STAFF REPORT ACTION REQUIRED

Application for Encroachment Agreement 267½ Glenholme Avenue (3rd Amendment)

Date:	October 16, 2007
To:	Etobicoke York Community Council
From:	Curtis Sealock, Manager, Municipal Licensing and Standards
Wards:	Ward 17 - Davenport
Reference Number:	ML&S Folder No. 06-139427 RAW

Attachment 4: Garage Detail

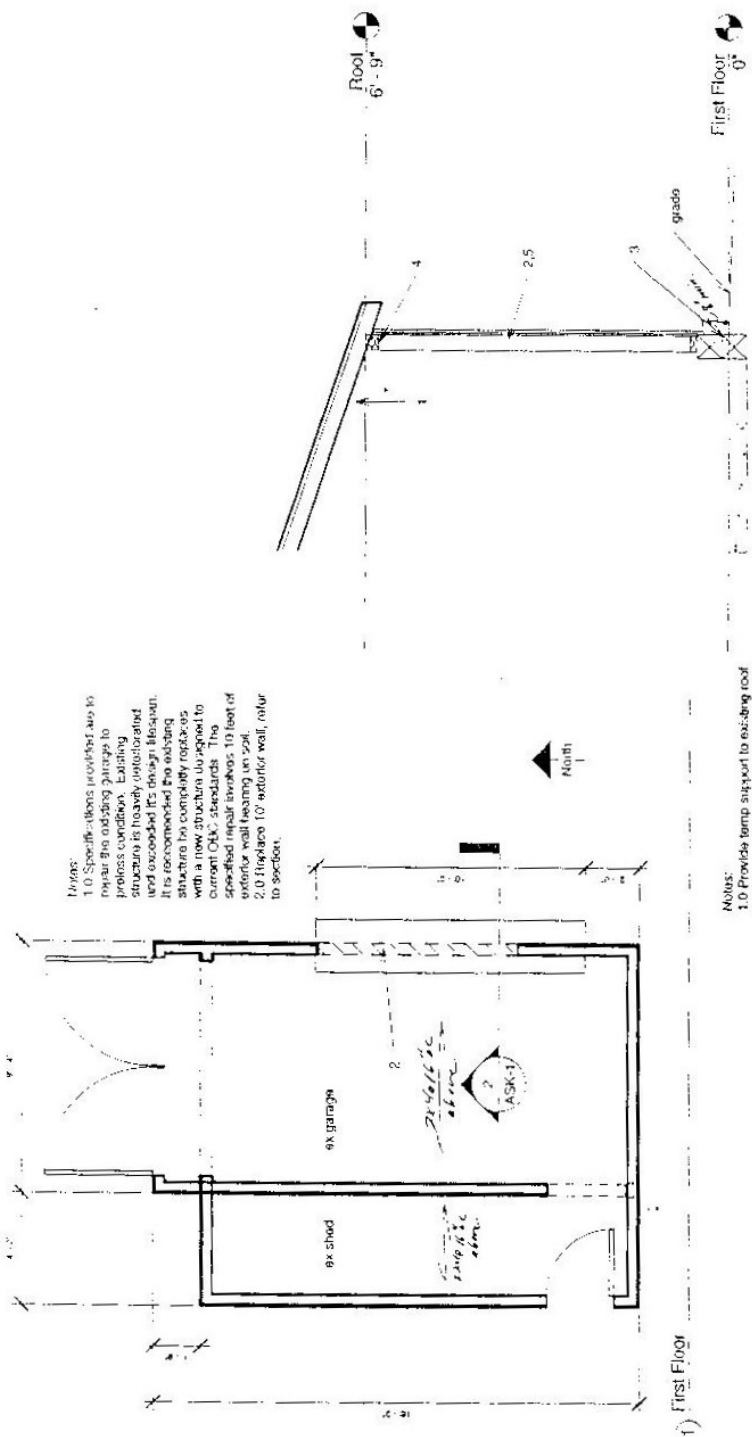
Notes:
 1.0 Specifications required to repair the existing garage to process conditions. Existing structure is heavily deteriorated. It is recommended the existing structure be completely replaced with a new structure to meet current OBC standards. The specified repair involves 10 feet of exterior wall bearing on soil.
 2.0 Replace 10' exterior wall, refer to section.

Notes:
 1.0 Provide ramp support to existing roof frame.
 2.0 Remove 10' of existing 2x4 wall on existing soil, abut to existing floor slab.
 3.0 Install 10' two ply 17' 6x6 timber sill on existing soil, abut to existing floor slab.
 4.0 Insert 2nd ply 2x4 top plate below existing single plate.
 5.0 Repair 2x4 wall @ 16" oc, 1/2" plywood sheathing. Finish with asphalt shingles.

Attachment 5: Hydro Requirements

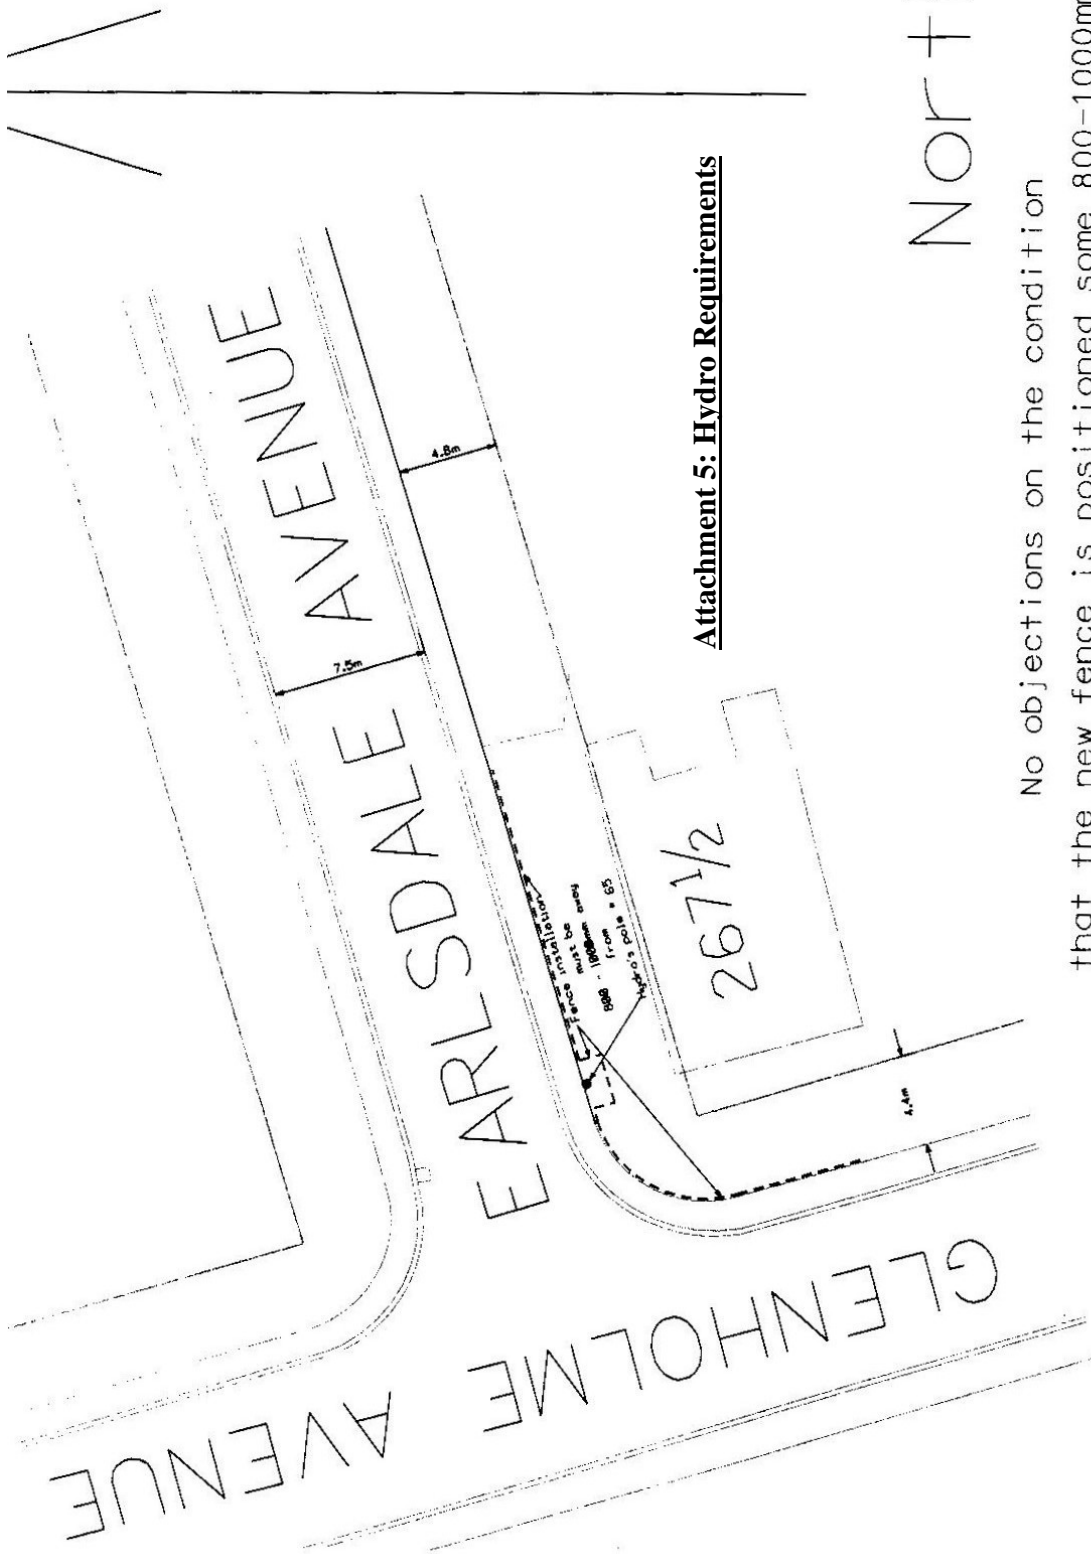
No objections on the condition that the new fence is positioned some 800-1000mm away from the perimeter of our Hydro pole# 65 !

3. if the subject chain link fence is replaced in future, it has to be realigned to allow a clearance of 800 mm – 1000 mm from the existing hydro pole on the Earlsdale Avenue road allowance, in compliance with the requirements of Toronto Hydro – Attachments 5 and 8;
